This proposal is to add two "Row Homes" at 1003 and 1005 McMath. This staff report will address 1005 McMath. 1003 McMath is a separate item on this agenda. The "Row House" is three stories tall with a gable front roof with stained oak horizontal siding on the front façade with a front loading single car garage. The entry to the house is a side entry near the rear of the house.

**STAFF RECOMMENDATION:** Denial

1. Application Date: 8-5-16
2. Date of Public Hearing: Sept 12, 2016 at 5:00 p.m.
3. Address of Property: 1003 - 1005 McMath Ave. 72202
4. Legal Description of Property: Lots 10-12 Block 5, Masonic Addition  
Pulaski Co. AR
5. Property Owner (Printed Name, Address, Phone, Email):  
Paul Page dwellings, llc  
324 E 15th St. L.R. AR 72202 PAULPAGEdwellings@SBCglobal.net
6. Owner's Agent: (Printed Name, Address, Phone, Email):  
\_\_\_\_\_  
\_\_\_\_\_
7. Brief Project Description: Two Row homes - single family  
\_\_\_\_\_  
\_\_\_\_\_
8. Estimated Cost of Improvements: \$340,000
9. Zoning Classification: Is the proposed change a permitted use? ☒ Yes ☐ No
10. Signature of Owner or Agent: Paul Page dwellings, llc  
(The owner will need to authorize any Agent or person represent

Site Plan submitted August 14, 2016

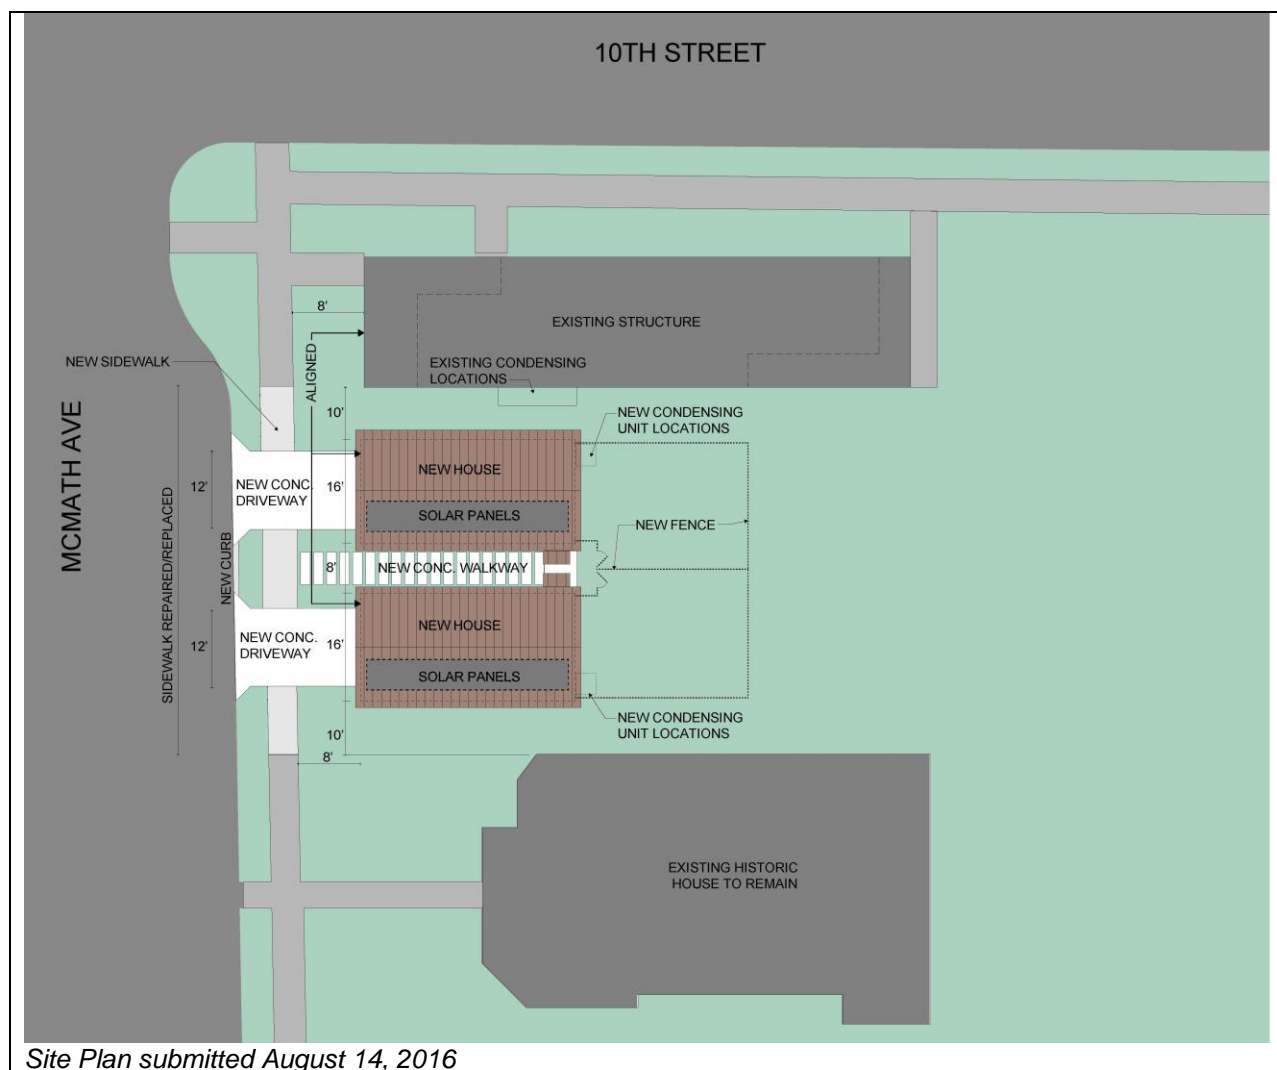
**SITING** The house will sit 10'-0" to the south of 1001 McMath, the mixed use building. It will sit 8'-0" north of 1005. The front setback will be aligned with the existing 1001 McMath. This setback relates to 1001 McMath and does not relate to 1007 McMath. With this house, 1005, sitting much closer to the street than 1007 McMath, the south side of the structure will be much more visible from the street. Large expanses of wall with little or no windows do not blend with the district.

The walk to entry door appears to be large concrete paver stones in concrete based on the site plan. No detail has been given.

Elevations submitted August 14, 2016

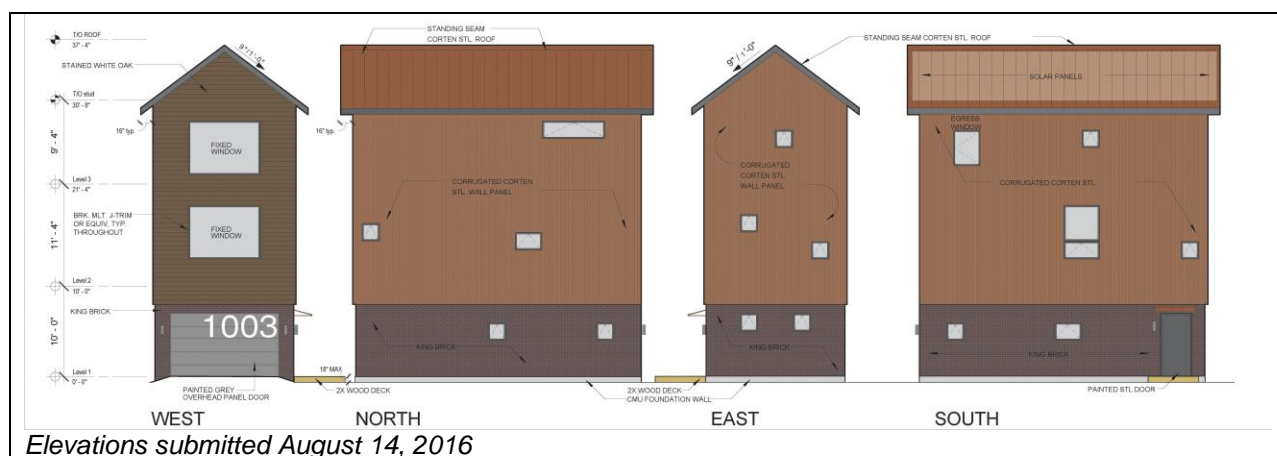
**PROPORTION** The proportion of this structure reads as very tall and skinny. This is a ratio of 1 wide to 2.41 tall. This is not a typical proportion for single family houses in the district.

**RHYTHM** The west side of the structure does have a rhythm, in the fact that there is one opening per floor and they are centered in the wall. The other facades do not have a discernable rhythm.

The side and rear facades feature two horizontal slit windows, twelve square windows, and two vertical windows, one which is ganged with a casement window under a fixed window. The ratio of solid wall to windows is atypical with so little of the walls being dedicated to windows. The windows are Anderson 100 series Awning and Casement windows in Bronze. The windows are made of Fibrex – a blend of 40 percent wood fiber by weight and 60 percent thermoplastic polymer by weight. The letter of August 14<sup>th</sup> states they will be casement and awning windows.

This house does not blend with the area of influence nor does it blend with the district as a whole in the design factors of Siting, Height, Proportion, Rhythm, Entrance area, Wall areas, Scale, and Massing. The placement of the house on the lot should relate more to the historic house at 1001 McMath. This would be the tallest structure within the area of influence.

The overall proportions do not blend with the district and the rhythm of the exterior walls is indiscernible. The overall ratio of wall area to window area is inappropriate with too few windows or the windows being too small. The scale and massing are also atypical to the neighborhood.
